DEVELOPMENT ASSESSMENT REPORT	
Application No.	MOD/2021/0329
Address	13 Jane Street BALMAIN NSW 2041
Proposal	Application under Section 4.55(2) of the Environmental Planning and Assessment Act 1979 to modify Determination No D/2018/535 which approved alterations and additions to a heritage listed dwelling-house and associated works, including new pool, now seeking various internal and external changes, including modifications to approved ground floor extension and rear cabana/outhouse, and new carport accessed via an easement across No. 11 Jane Street
Date of Lodgement	13 August 2021
Applicant	Brook Lane Property Group Pty Ltd
Owner	Ms Justine A McCarthy Mr Jason P Ockerby
Number of Submissions	Initial: 1
Value of works	\$1,079,500.00
Reason for determination at Planning Panel	Works to Heritage Item
Main Issues	Demolition of significant heritage fabric Overshadowing
Recommendation	Approval, subject to conditions

This report is an assessment of the application submitted to Council for Section 4.55(2) of the Environmental Planning and Assessment Act 1979 to modify Determination No D/2018/535, which approved alterations and addition to heritage listed dwelling-house and associated wo

Figure 3: Section of carport roof overshadowing No. 7 Bradford Street.

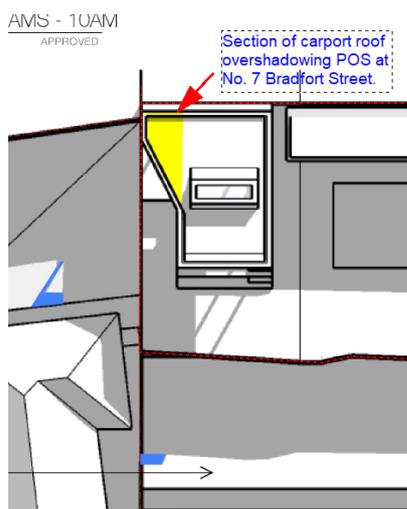
Comment: The pole and triangular section of the roof that is closest to the shared boundary with No. 7 Bradford Street (Figure 3) is causing the additional shadows onto the private open space at No. 7 Bradford Street. Whilst it is acknowledged that the width of the car parking space at the shared boundary with No. 11 Jane Street is required for vehicle manoeuvrability, it is not considered that the same area is required to be covered.

The additional shadows cast onto the private open space at No. 3 and 5 Bradford Street is caused by the height of the carport, which could be eliminated by reducing the overall height by approximately 500mm. As outlined above, the proposed floor to ceiling height of 2.6 metres is unnecessary. Further, to support the depth of the green roof/planter, the roof of the carport has a thickness of 500mm, which is also considered to be unnecessary. By amending the design to a simple skillion roof without a green roof, the height of the carport can be readily reduced.

- The carport must be amended as follows:
 - The roof must be set back from the western boundary by, at least, 1.8 metres for the entire length.
 - The roof planter/green roof and splayed skylight must be deleted.
 - The overall height must be reduced by at least 500mm, the ridge, at any point, must not be higher than RL37.1.
 - The roof must be amended to a skillion roof form, either sloping down from north to south, or from east to west.
